Technical Service Information

FORD AXOD HARSH COAST DOWNSHIFTS

FIGURE 1

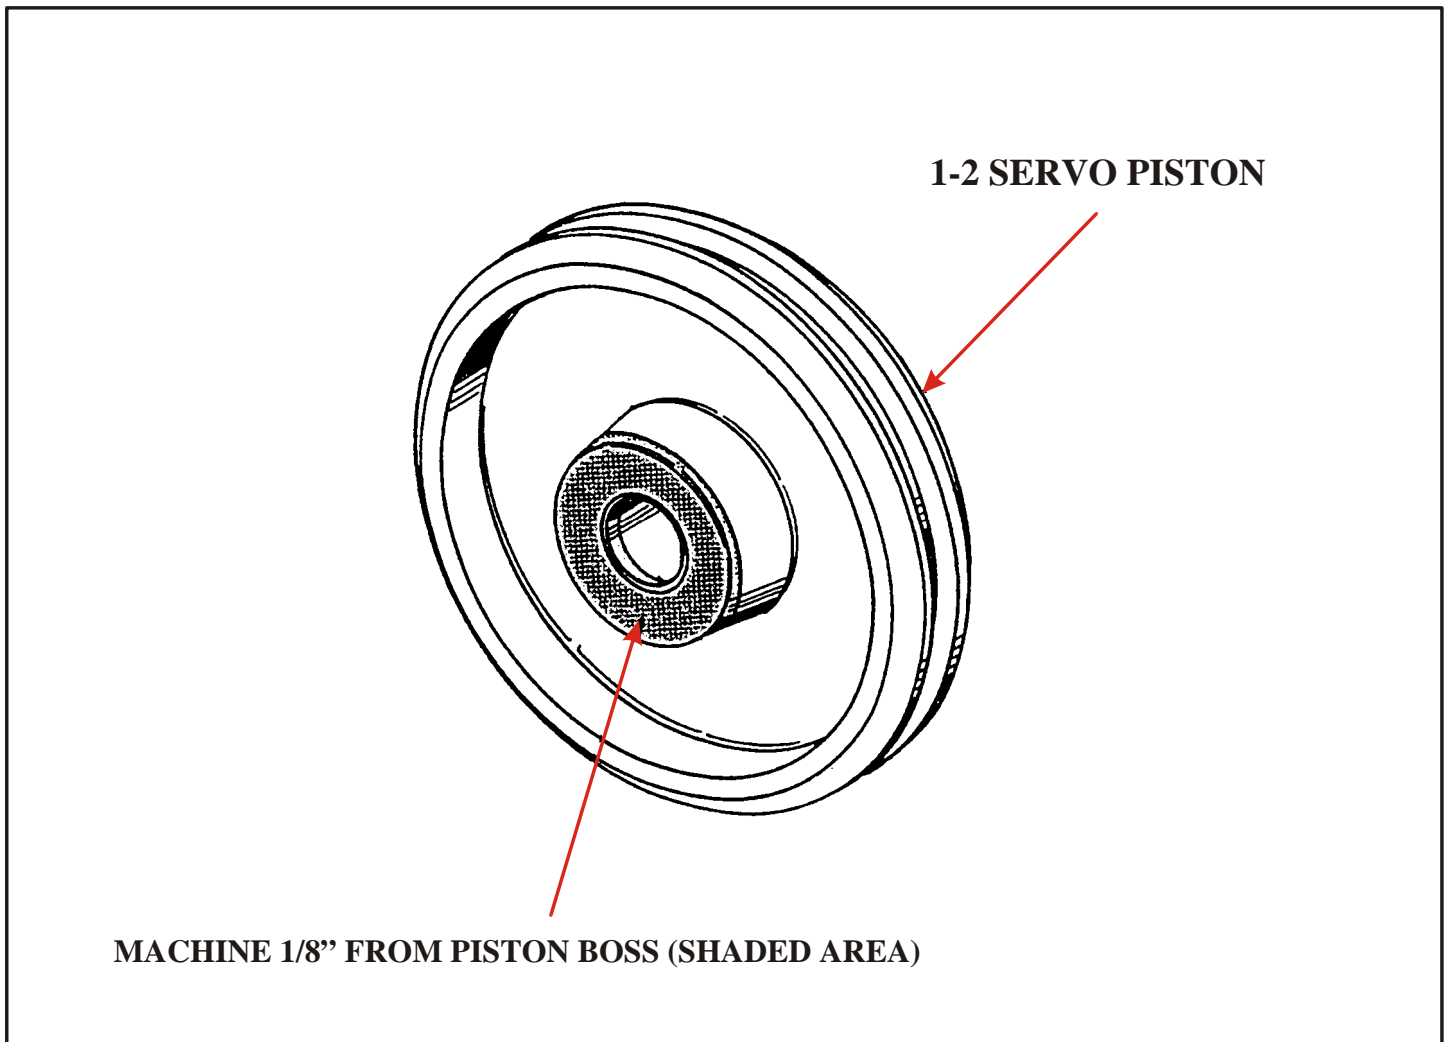
COMPLAINT: Harsh downshift when coasting to a stop at closed throttle.

CAUSE: Insufficient travel of the 1-2 piston against the cushion spring.

CORRECTION: Remove 1/8" from the boss on the inside of the 1-2 servo piston as shown in Figure 1. We have shaded the area to be machined.
